95.7.2 100GBASE-SR4 receive optical specifications

95.8.8 Stressed receiver sensitivity

Figure 95-5—Stressed receiver conformance test block diagram

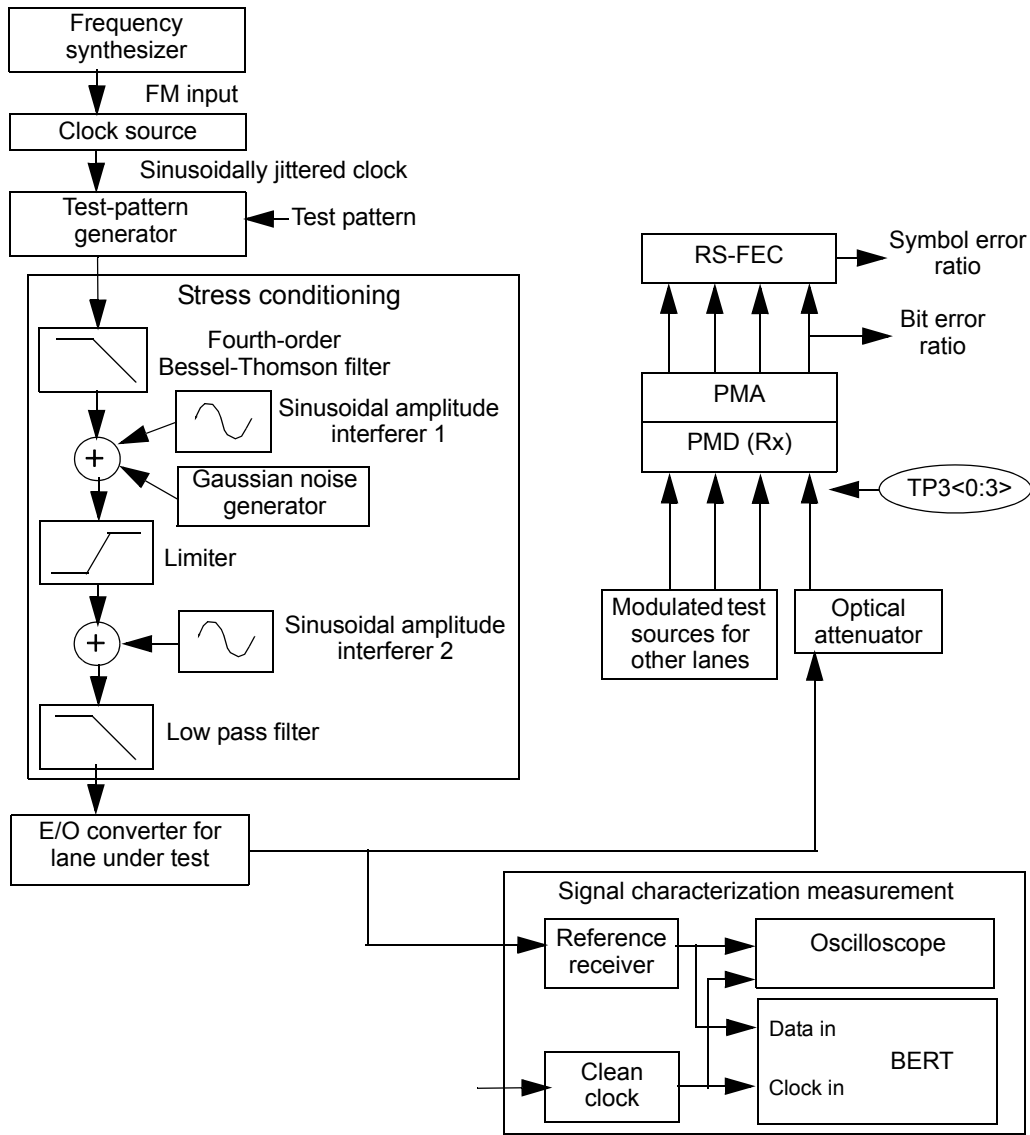
An example stressed receiver conformance test setup is shown in Figure 95–5, however any approach that modulates or creates the appropriate levels and frequencies of the ~~VECP-TxVEC~~ and jitter components is acceptable.

With the sinusoidal interferers, sinusoidal jitter, and Gaussian noise generator turned off, greater than two thirds of the dB value of the ~~VECP-TxVEC~~ should be created by the selection of the appro-

appropriate bandwidth for the low-pass filter. Any remaining VECP-TxVEC must be created with a combination of sinusoidal jitter, sinusoidal interferer 2 ~~or sinusoidal jitter~~, and the Gaussian noise generator.
